Road Safety Audit
Stage 1
for
BRAY SUSTAINABLE TRANSPORT BRIDGE
BRAY, CO WICKLOW

Date: September 2020

Report produced by: Road Safety Matters Ltd

Reference: RSM/MOB/130320/DARGLE BRIDGE-RSA1

Figure 8: Fencing removed adjacent to embankment

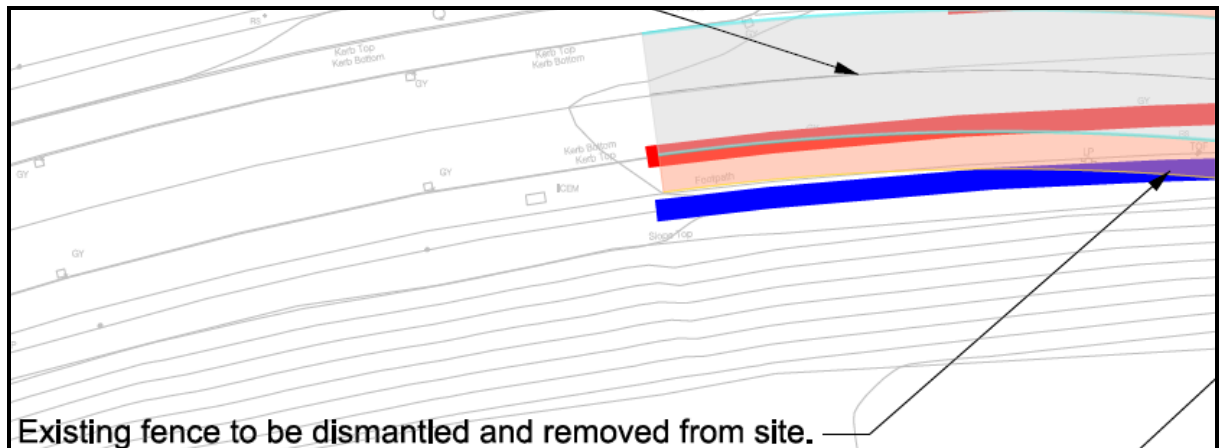
There were no details provided in respect of treatment of the edges of the cross section for the proposed road in terms of fencing or retaining walls, particularly adjacent to VRU facilities at locations where significant level differences will arise between the carriageway level and the adjacent land. The site clearance plans indicate that fencing will be removed from approximate ch 35-70m, as indicated in figure 8, and there is no provision for replacement fencing. Existing fencing at this location is shown in figure 9, which prevents pedestrians, including children, from accessing the embankments and exposed water hazards.

Elsewhere along the proposed link, fencing and boundaries will be located very close to the carriageway edges, where there is an increased risk of being struck by passing vehicles. At Junction 2, there are proposals to set back the existing kerb which will impact on levels and an existing retaining wall at this location, which is shown in figure 9, and the final levels and all proposals have not been shown.

Detailed design should include provision for fencing proposed boundaries where necessary along both sides of the proposed route, at a sufficient offset from the carriageway edge. All boundary heights on approaches to junctions to be provided at levels below 1.05m to ensure visibility and SSD are not compromised. Details of any new or relocated retaining walls should also be provided at detailed design stage.

Figure 10: Restrictive geometry at Junction 1

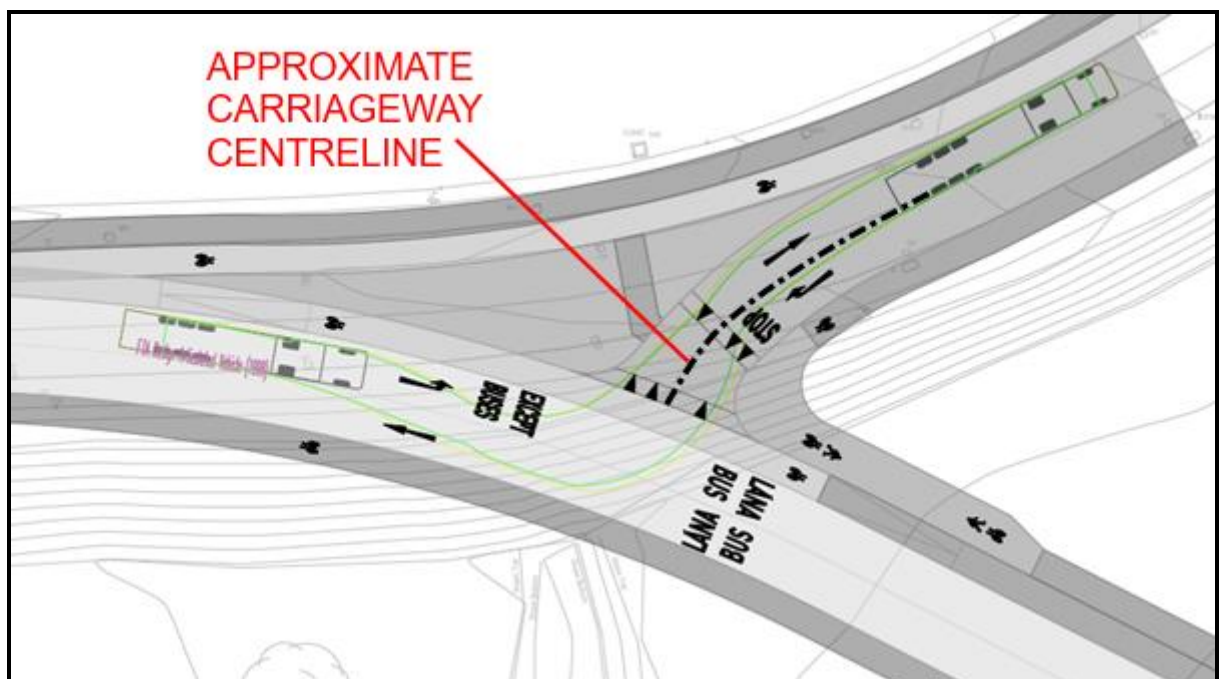
Swept path analysis has been provided for an articulated vehicle, which shows significant encroachment into the opposing traffic lane at Junction 1, presenting a head on or side swipe collision risk. Whilst it was considered that vehicles of this size are likely to be infrequent, presenting a relatively low level of risk, it is unclear if the proposed geometry will operate safely with more frequent vehicle types, to facilitate two-way traffic movement at all times. Figure 10 shows the restrictive geometry at Junction 1.

The provision for road user continuity to the east of Junction 1 is unknown, and vehicles are prevented from travelling underneath the railway bridge at present due to the presence of gates, as shown in figure 11. There is no provision for a suitable turning circle and cul de sac signage as necessary at this location to prevent vehicles proceeding in error and having to make multiple reverse manoeuvres at a location where there is likely to be a high proportion of VRUs circulating on the footway/cycle track network, particularly at school start and finish times.

The swept path analysis should demonstrate that the geometry of the proposed junctions will accommodate the turning movements of all anticipated vehicle sizes with adequate margins of safety, and should demonstrate that vehicles waiting to turn out of the minor roads will not obstruct entry for vehicles turning in. The demand for access to the minor road to the northeast of Junction 1 should be clarified, with suitable signage to be provided to restrict access, or provision made for a suitable turning circle as necessary, particularly for larger vehicles, due to the current height restriction on the railway bridge, as shown in figure 12.

Figure 13: Restrictive geometry at Junction 2

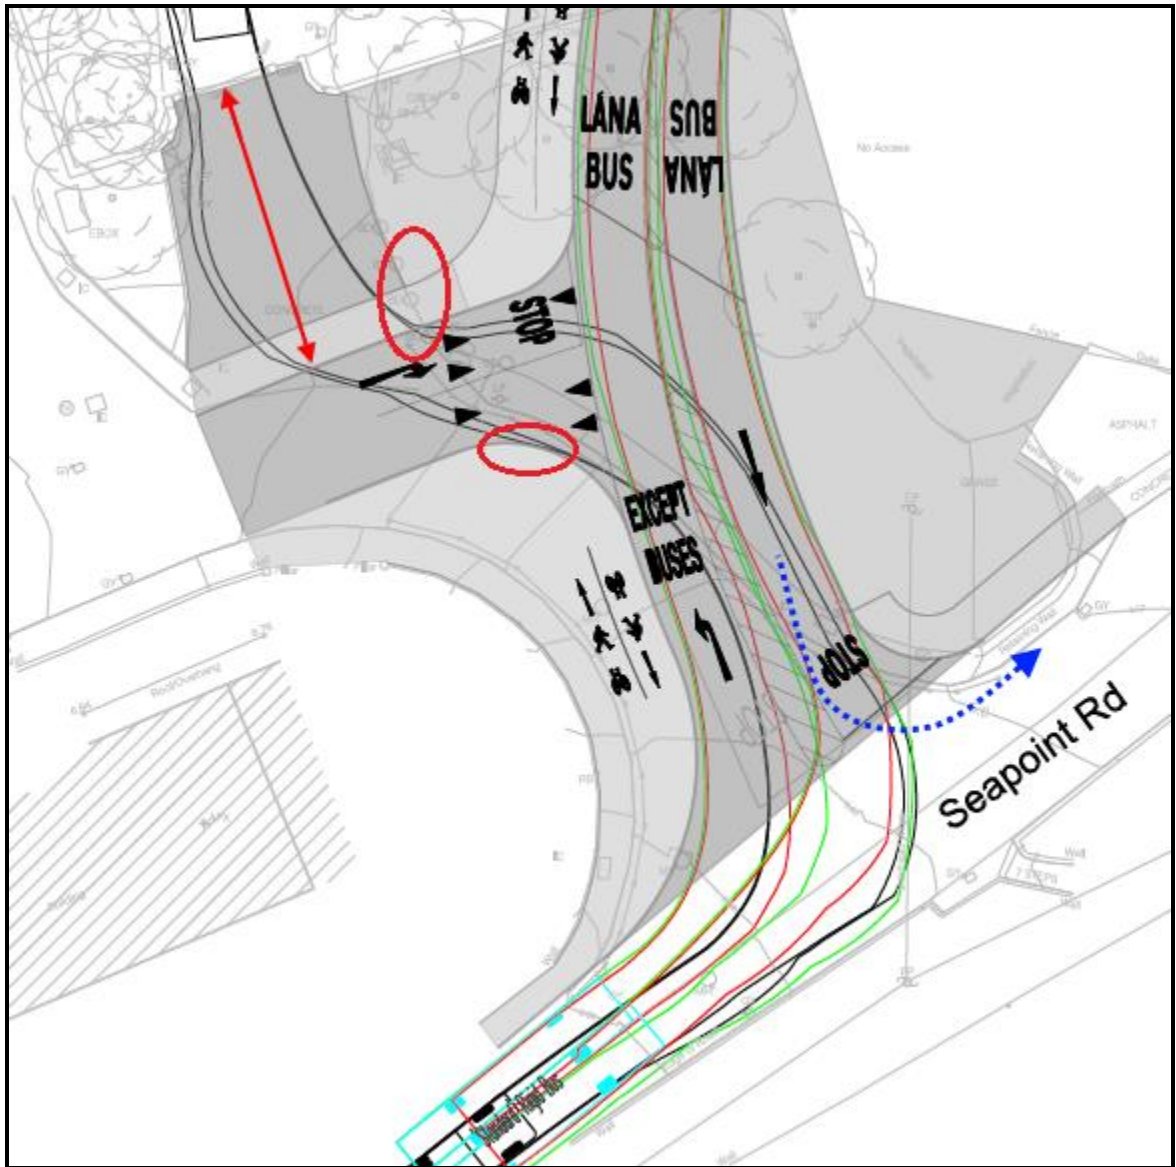
At the Seapoint Rd Junction, there is very little margin of error for articulated vehicles to access the gated entrance to the pump house, as shown in figure 13, and the vehicle turning left from Seapoint Road must encroach almost fully onto the opposing side of the carriageway in order to make the turn. Vehicle encroachment onto the adjacent footways is considered likely, which increases risks to VRUs, including pavement damage and trip hazards. There are a number of existing bollards located immediately adjacent to the entrance, as shown in figure 14, with limited clearance to the swept path, increasing the risk that these bollards will be struck. It was noted that the gates into the pump house do not appear to be set back a sufficient distance from the carriageway to enable the entering vehicle (16.5m articulated vehicle) to wait safely off the carriageway for the gate to be opened, without obstructing pedestrians on the footway, as well as passing vehicles. This risk may arise at present, however pedestrian flows on this section of footway are likely to increase as a direct result of the new link and bridge construction, which will increase the inherent level of risk.

The proposed geometry should accommodate the swept paths and turning movements of all anticipated vehicle sizes within the proposed layout with adequate margins of safety. The location of the gate at the access to the pumping station should ensure vehicles can wait safely off the carriageway without obstructing pedestrians or motorists. The existing cross section on Seapoint Rd should be reviewed to ensure safe two way movement of buses can be accommodated as necessary, with suitable clearance to be provided to hazards adjacent to the carriageway (minimum advisable 600mm to solid continuous hazards). Gradients should also be reviewed on approaches to all junctions, particularly the approach to Seapoint Rd at junction 2, with a level dwell area to be provided for a minimum 15m back from the channel line.

**Figure 16: Overlapping two-way movement for buses.
(Note Sudden Topo Survey termination)**

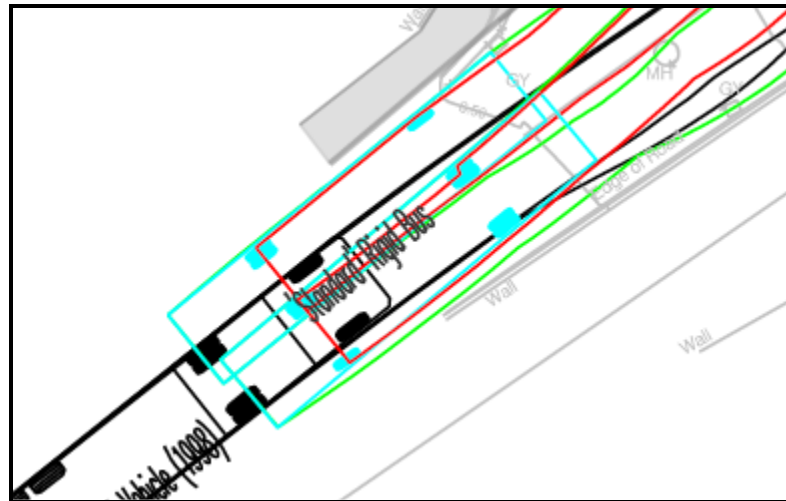
At the intersection with Seapoint Road, there is no swept path shown for the left turn movement out of the junction, which is the most restrictive movement at this junction due to the tight radius. The topographic survey terminates abruptly on the southwestern side, however it appears the existing cross section on Seapoint Road will not safely accommodate two-way movement for buses, with significant overlapping noted on the swept path analysis, as shown in figure 16, and no safe clearance to solid continuous walls which present a linear hazard along the southern

side of the carriageway, as shown in figure 17. Two wheeled vehicles would also be more vulnerable on this narrow cross section as a result of increased volumes of buses arising from demands to use the new public transportation bridge.

Figure 23: Significant obstructions in visibility splay to right from new minor rd junction

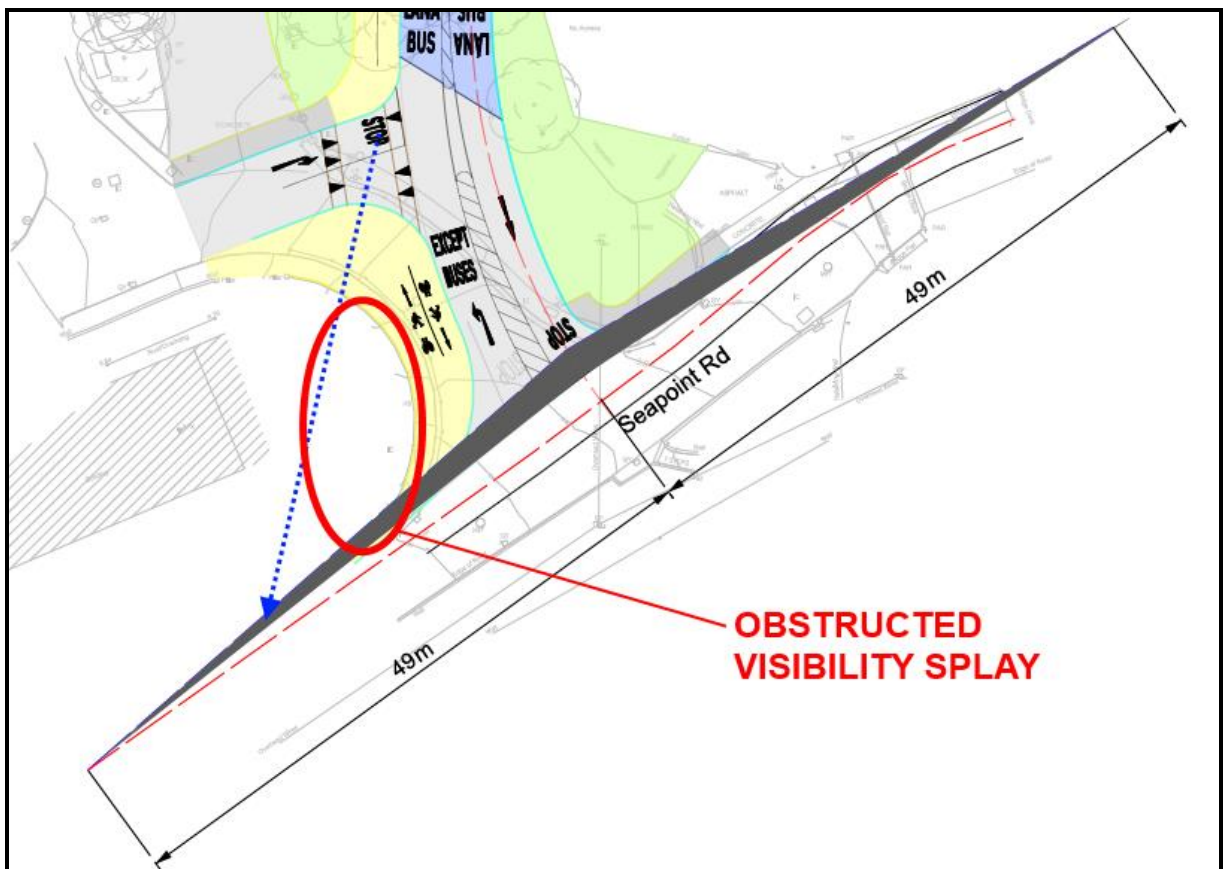
The minor road access into the Seapoint Court residential area will be realigned to accommodate the new bridge and public transport link. Visibility to the right from this location is also obstructed by the existing boundary treatment at this location, as shown in figure 22, which is taken from the location of a pedestrian wishing to cross the junction mouth, which will increase the risk of pedestrian/vehicular conflict. Visibility to and from waiting vehicles will also be compromised, even taking into account the significantly reduced visibility requirements of DMURS, as indicated in figure 23. Obstructions in visibility splay increases the risk of pulling out incidents and right angled collisions, as well as potential rear shunt collision risks, which would be exacerbated by the potential for vehicles being obstructed by the restrictive geometry, as outlined in paragraph 2.2.2 (see figure 13).

Visibility Splays should be provided for all junctions, and should clearly show x and y dimensions, with the y dimension taken to the channel line on the major road in each direction, or the major road centreline for the y dimension to the left, where a solid centreline has been provided to prevent overtaking manoeuvres. Visibility splays should be clear and unobstructed at all times in accordance with traffic speeds, and sufficient traffic calming measures should be provided to demonstrate reduced vehicle speeds to enable reduced

Figure 24: Visibility Splay Provided for Junction 1

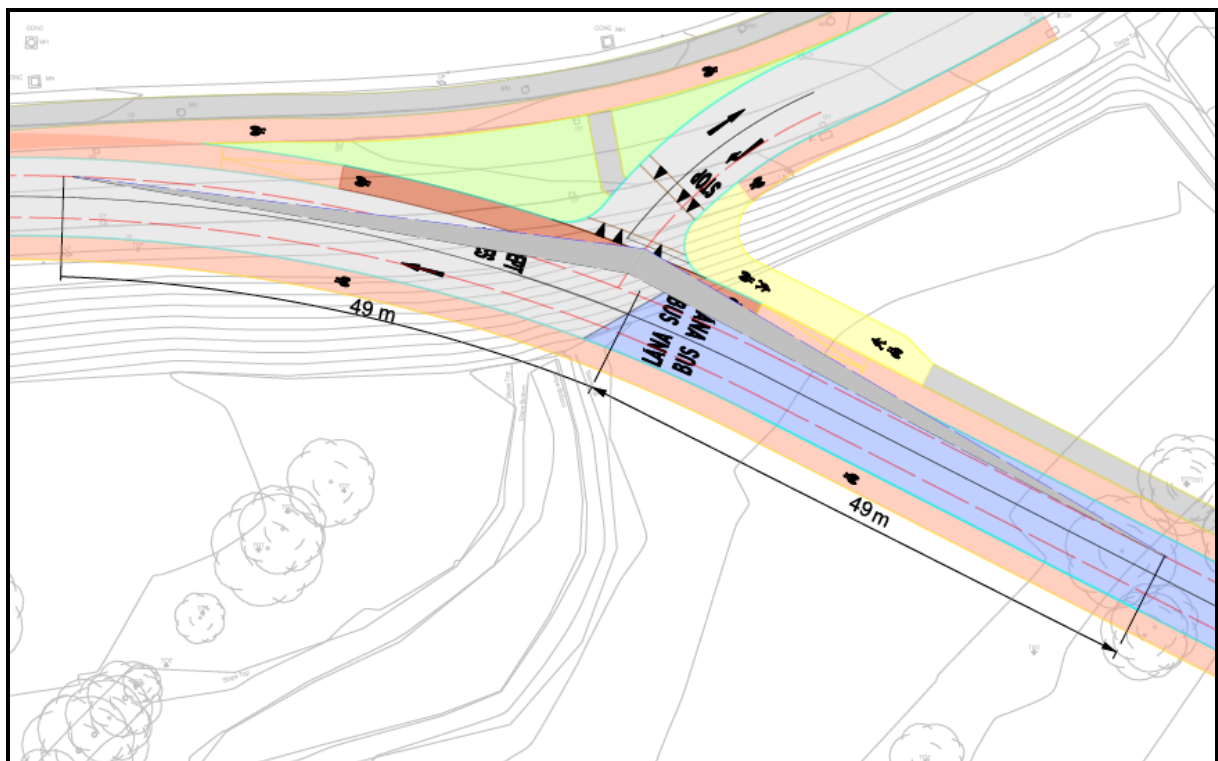
It was noted in respect of the visibility splay drawings provided, that there was no visibility splay drawing provided for the minor road access into the Seapoint Court residential area. Visibility splays have been shown for Junction 1 and Junction 2 at the intersection of Seapoint Rd, however the y dimension appears to be taken to the centreline of the carriageway rather than the channel line, and the x distance has not been taken from the centreline of the minor roads, as shown in figures 23 and 24, which is the typical methodology used to demonstrate visibility. The x-dimension is also not shown.

Figure 25: Successive curves with low radii and no transition length

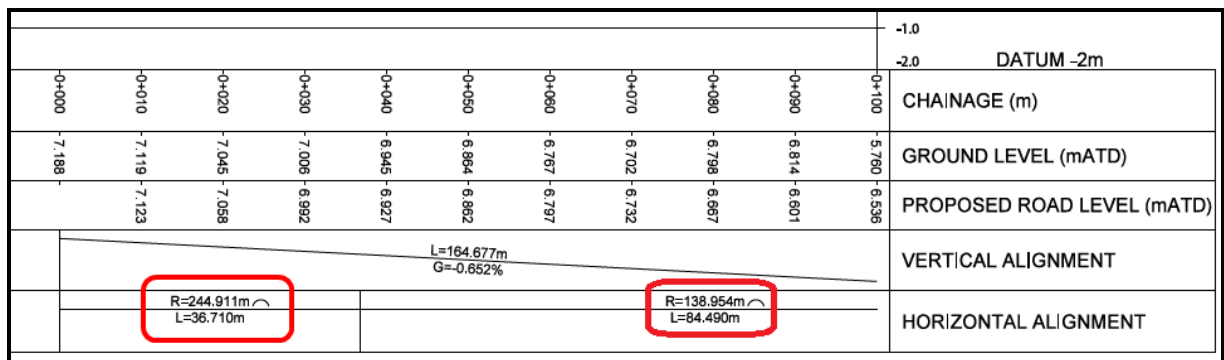
2.2.4.1 The horizontal radii used on the proposed bridge and link alignment appear low at a number of locations, as shown in figures 25, 26 and 27. Collision rates are higher on lower radii and on consecutive curves with low radii, with collision rates increasing significantly on curves with radii lower than 250m, particularly head on or side swipe collisions on single carriageways, with collision risk increasing significantly in proportion to curve frequency. Low radii may also increase the risk of vehicular loss of control on the outside of a bend, particularly in wet and icy conditions, and may also increase passenger discomfort on buses, with an increased risk of sudden breaking when negotiating tight radii.

The curve radii should be increased to include suitable transition curves, with radii lower than 250m to be avoided, in the absence of suitable traffic calming measures. The transition to sharper curves should be carried out by progressive reduction of radii along sequential curves, and overtaking should not be permitted on approaches to low curve radii, where the likelihood of limited SSD is increased. The alignment should also be reviewed to avoid locating the bridge on a curved horizontal alignment if possible.

Figure 28: Coincidental sharp horizontal and vertical curvature

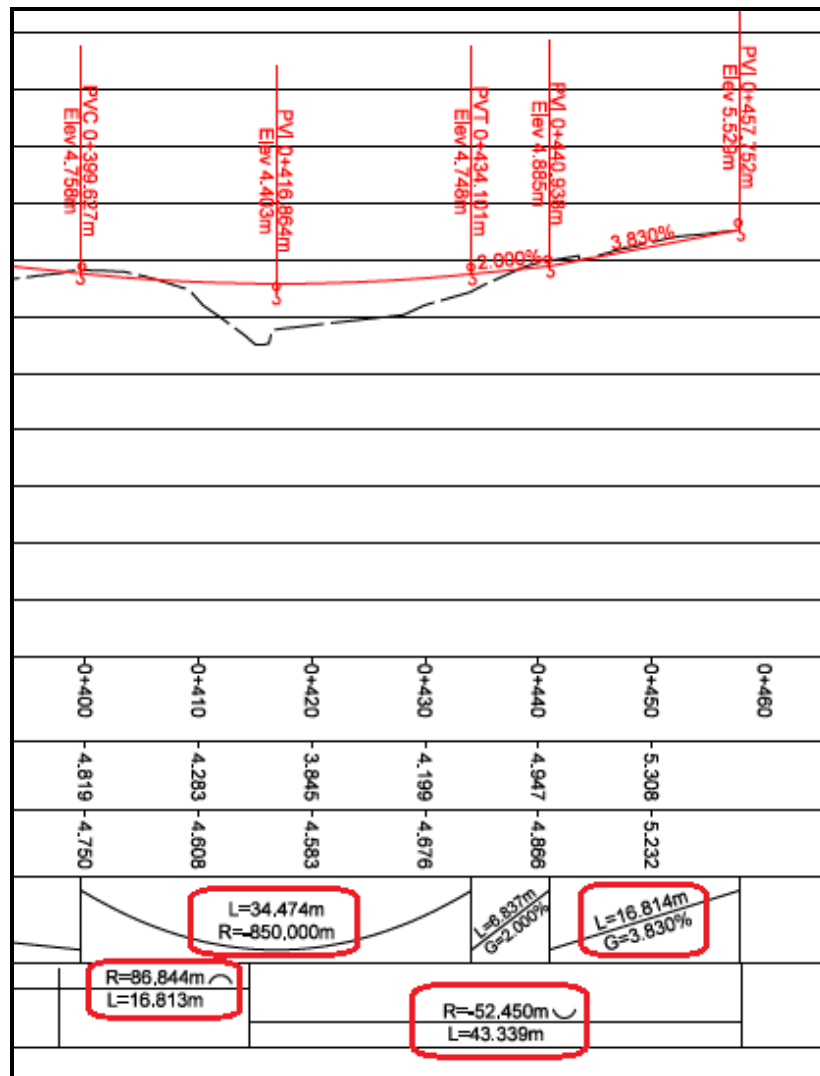
2.2.4.3 Relatively sharp curves have also been used on the proposed vertical design, e.g. at approximate chainage 400-434m, where a radius of 850m has been used over a short length, and at ch 399-434m and ch 165-195m. In some cases, the sag curves appear to be lower than one step below the desirable minimum, including on the approach to Junction 2. Such relaxations are not typically permitted on approaches to junctions. At some of these locations the short, relatively sharp vertical curves are coinciding with low radii horizontal curves, including on the bridge and on the approach to Junction 2, as shown in figure 28. The coincidence of a horizontal and a crest vertical curve may, under certain conditions, lead to significant limitation of

the available sight distance and prevent the prompt perception of the curve, leading to an increased risk of loss of control. An inefficient combination of horizontal and vertical alignment may lead to road safety problems, even when the horizontal and the vertical alignment comply separately with all relevant design standard and guidelines. Poor coordination of horizontal and vertical alignments can create locations where the available sight distance drops below the required sight distance. It is therefore unclear if there is sufficient SSD over the crest curve on the bridge on the westbound approach towards the proposed toucan crossing at approximate chainage 200m, to ensure clear intervisibility between approaching motorists and pedestrians waiting to cross, including small children. Further details on potential intervisibility obstructions at this location have been outlined in section 2.3 of this Stage 1 RSA report.

Forward visibility and SSD should be clear and unobstructed at all times in accordance with traffic speeds, particularly on approaches to VRU crossing points, where VRU priority and safety should be maximised. The vertical design for the scheme should be reviewed taking into account all issues raised above, with the design to be amended where possible to provide flatter gradients, taking into account drainage requirements to minimise the risk of standing water.

Relaxations from minimum required should be isolated from other relaxations, on both the horizontal and vertical planes. Final design should ensure there are no sudden changes in level particularly at junctions and locations where vehicles will be turning within a relatively confined space, and where the risk of overturning is higher. Detailed design contours should be checked at this location, and at all others throughout the scheme, to ensure surface water is adequately drained and that ponding will not occur within the carriageway, leading to an increased risk of loss of control during wet and icy conditions.
